Rezoning Transportation Analysis

Petition Number: 2022-216

Date	Description
05-24-2023	First Review (JP)
11-27-2023	Second Review (TP)
12-19-2023	Third Review (IW)
01-24-2024	Fourth Review (KC)

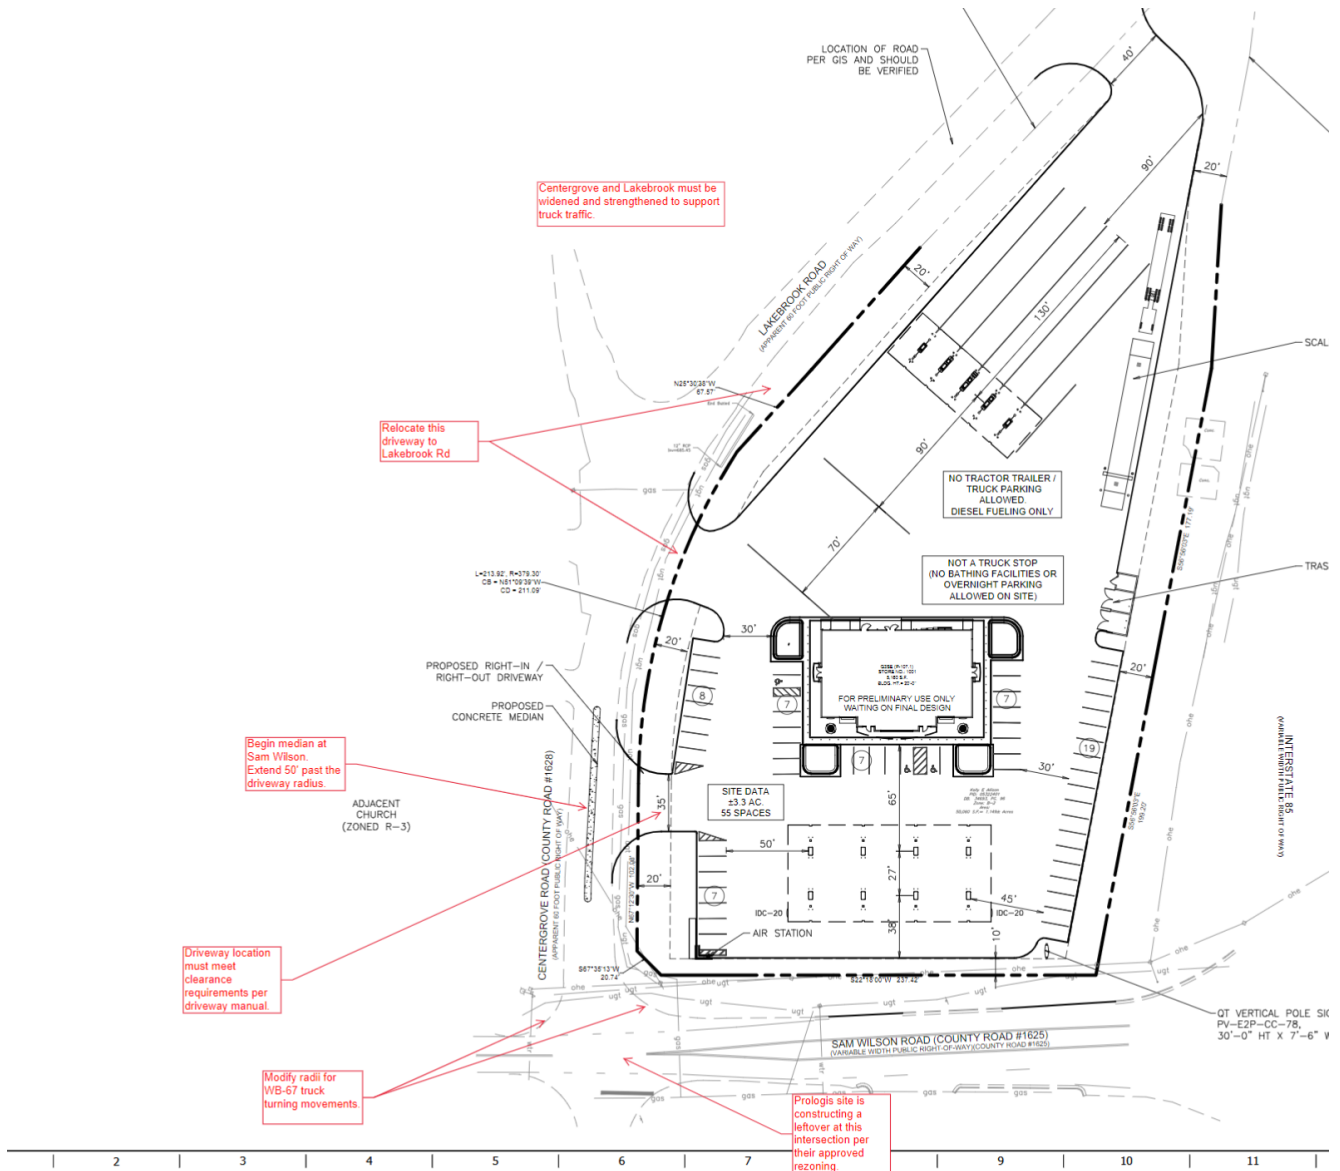
2. ~~Traffic Study:~~

~~A Traffic Impact Study is required for the complete review of this petition due to the site generating more than 2,500 daily trips and/or triggering other City TIS requirements. CDOT has received the submitted TIS and is currently reviewing the petition. Additional comments will be provided on the rezoning plan once the TIS is approved.~~

~~Staff will receive the petition and begin review, but the public hearing will not be scheduled until the TIS is approved to allow for the minimum time necessary for CDOT to review the study and reach agreement with the petitioner on the required transportation commitments. Any agreed upon commitments shall be included on the last site plan submitted no fewer than 4 weeks prior to the public hearing. Therefore, additional traffic mitigation comments may be forthcoming once the TIS is approved by CDOT (and NCDOT).~~

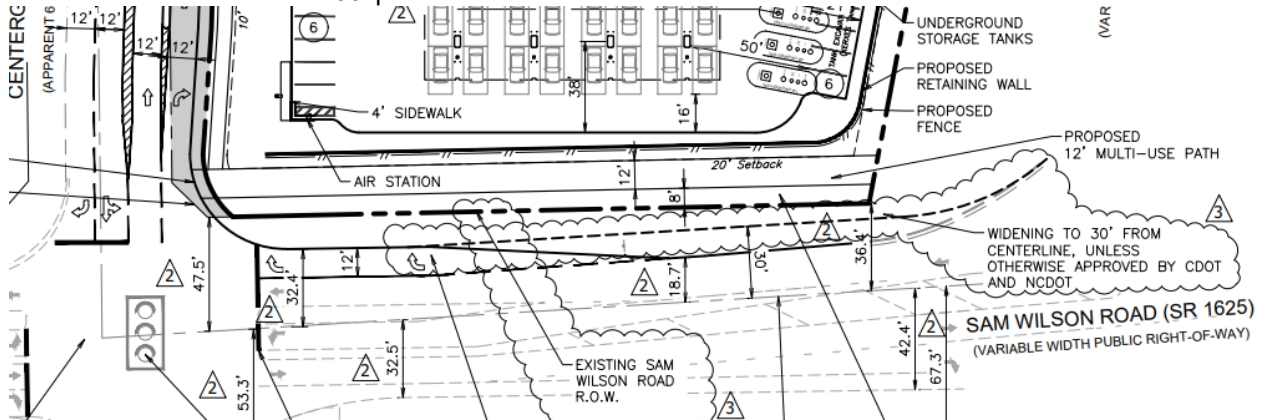
4. ~~Revise site plan and conditional note(s) to commit to dedicate 35 feet of right of way from the road centerline on Sam Wilson Road. The site plan shall label and dimension the right of way from the road centerline.~~

Clarifying comment 11.27.2023: Label and dimension right of way from roadway centerline on Sam Wilson.

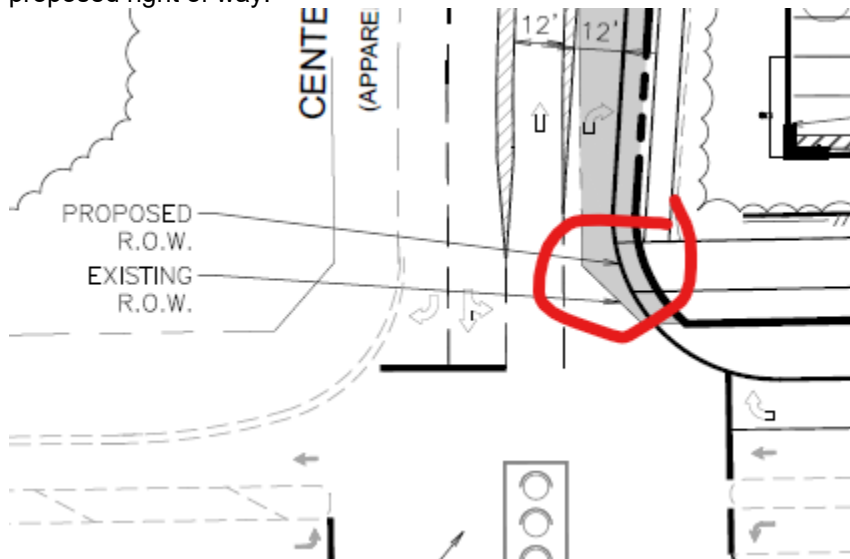
- New comment 01.24.2024:** Conflict with revised site plan and conditional notes, site plan shows 30' and conditional note states 35' please address.

- New Comment 12-20-2023:** Revise site plan to clearly show and label the location of existing right of way and proposed right of way.

Clarifying comment 01.24.2024: Label and clearly dimension the existing right of way and the proposed right of way.

4. Prior to the issuance of the first certificate of occupancy for the building to be constructed on the Site, Petitioner shall dedicate and convey to the City of Charlotte or to NCDOT as applicable (subject to a reservation for any necessary utility easements) those portions of the Site located immediately adjacent to Sam Wilson Road as required to provide right of way measuring **35 feet** from the existing centerline of Sam Wilson Road, to the extent that such right of way does not already exist.
